BRUNSWICK STEAM ELECTRIC PLANT, UNIT NOS. 1 AND 2
DOCKET NOS. 50-325 AND 50-324/LICENSE NOS. DPR-71 AND DPR-62
BRUNSWICK SIMULATOR CERTIFICATION - REQUEST FOR ADDITIONAL INFORMATION

RESPONSE TO SIMULATOR CONCERNS

Figure 3
Current Simulator Back Panel Arrangement

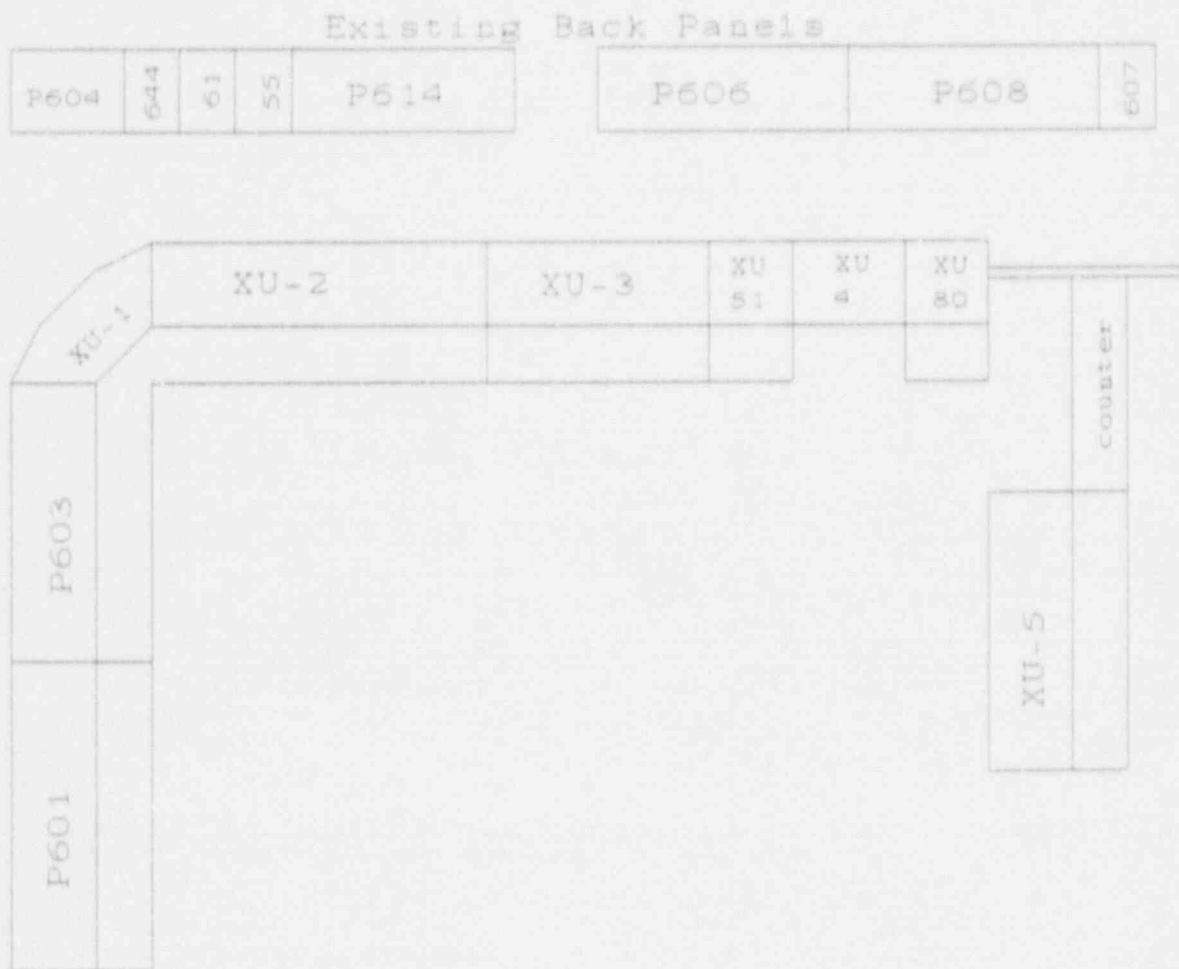
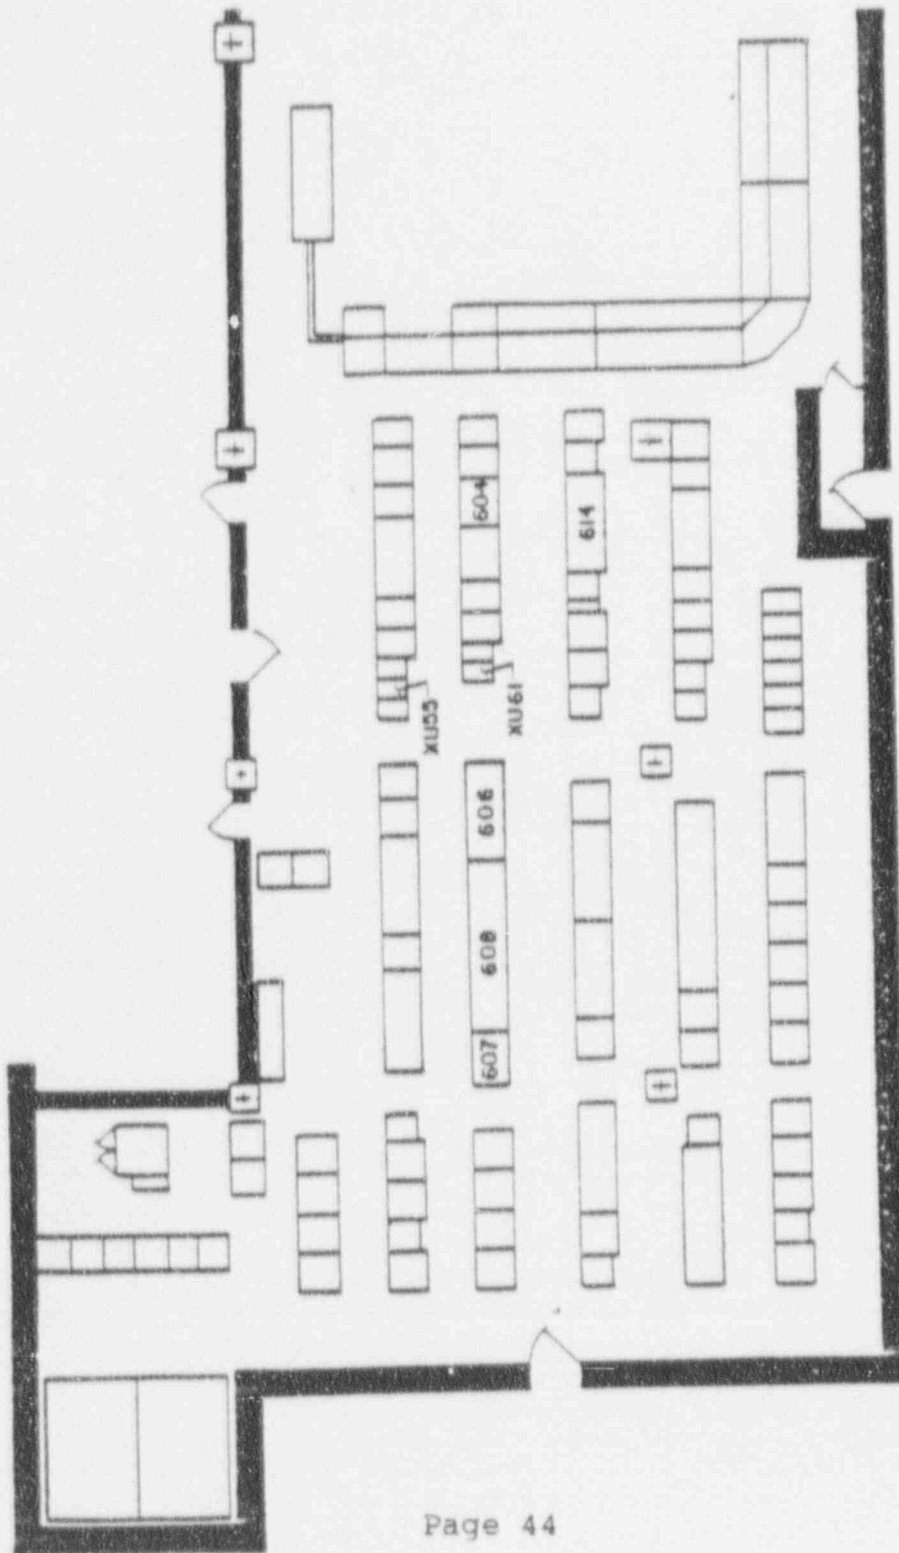
Appendix C, "Simulator Back Panel Plans," indicated that a training value assessment has been completed and that modifications to the simulator resulting from this assessment are scheduled to be completed by July 31, 1993. This schedule is not in accordance with the guidance of ANSI/ANS-3.5-1985, Sections 5.2 and 5.3, which allow for 12 months to review the need for modifications and an additional 12 months to implement modifications. Please provide justification for exception to the guidance of ANSI/ANS-3.5-1985, Sections 5.2 and 5.3, or provide a revised schedule which is in accordance with this guidance.

Sections 5.2 and 5.3 of ANSI 3.5 ensure simulators are maintained as closely as possible with the reference plant following plant modifications, upgrades, and other improvements. The Back Panel project was not driven by the need for improvement due to an upgrade or improvement to the plant but by a Training Assessment to determine the need for additional training or training in a different setting.

As a result, changes to the simulator as part of this project are considered enhancements to the simulator to support a training need and not a modification based on a plant change. Consequently the two year requirement of the Standard does not apply. The project is currently on schedule.
